**FUEL SYSTEM—FILLER CAP SEPARATION—  
VEHICLES BUILT FROM JOB 1 TO 6/1/91**

**Article No.  
92-8-7**

**MERCURY:** 1991-1992 CAPRI

Figure 1 - Article 92-8-7

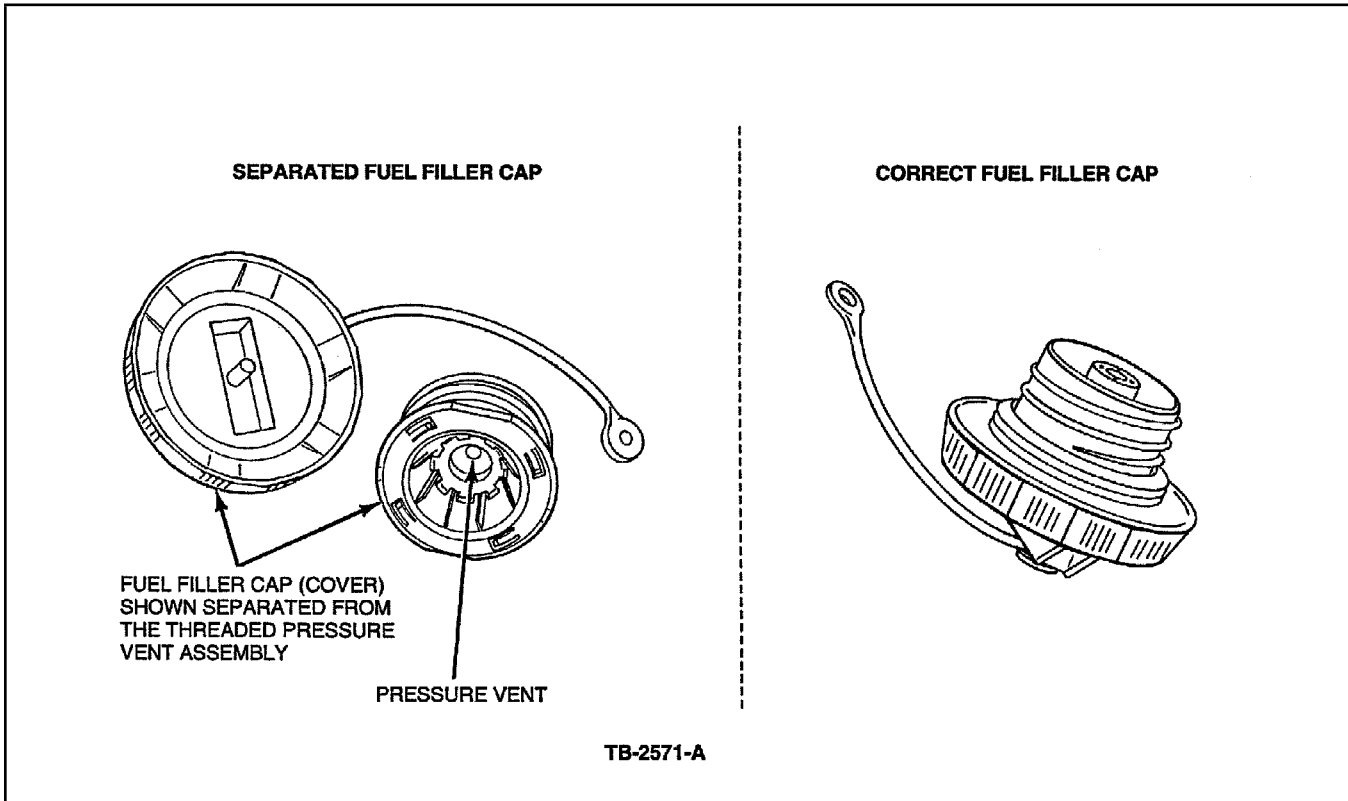
The fuel filler cap cover may separate from the threaded pressure vent assembly. If the cover separates from the threaded assembly, the seal and retaining threads may remain in the fill pipe and can be sealed by tightening.

**NO ATTEMPT SHOULD BE MADE TO MODIFY OR REASSEMBLE AN EXISTING FUEL FILLER CAP WHICH HAS SEPARATED. IF THE SEPARATION CONDITIONS OCCURS, REPLACE THE FUEL FILLER CAP ASSEMBLY WITH ONE WHICH HAS A MANUFACTURING DATE STAMP AFTER MAY 7, 1991. REFER TO FIGURES 1 AND 2.**

Replace the fuel filler cap assembly.

Figure 2 - Article 92-8-7

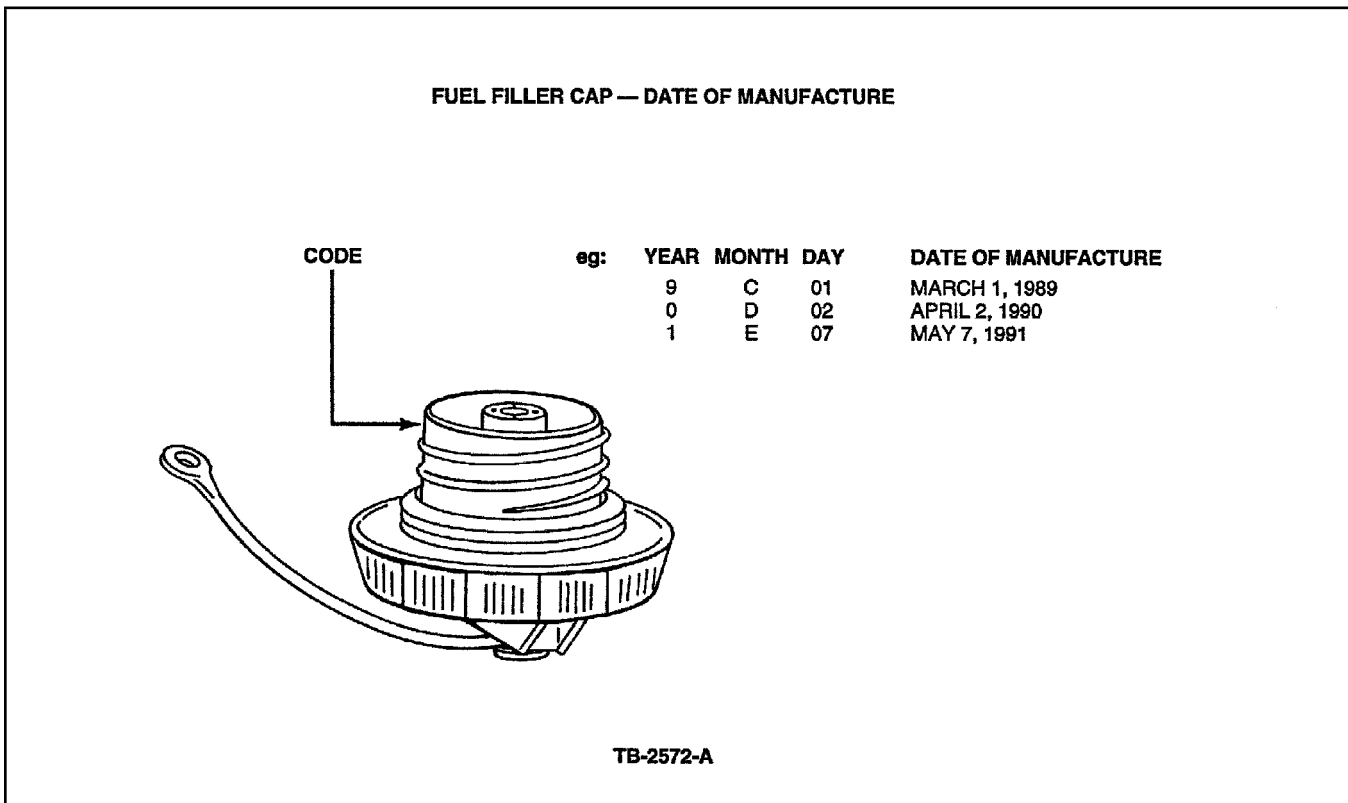
**ALL FUEL FILLER CAPS ARE DATE STAMPED AT THE BASE OF THE CAP INDICATING YEAR,**

**MONTH AND DAY OF MANUFACTURE. REFER TO FIGURE 2 FOR IDENTIFICATION.**
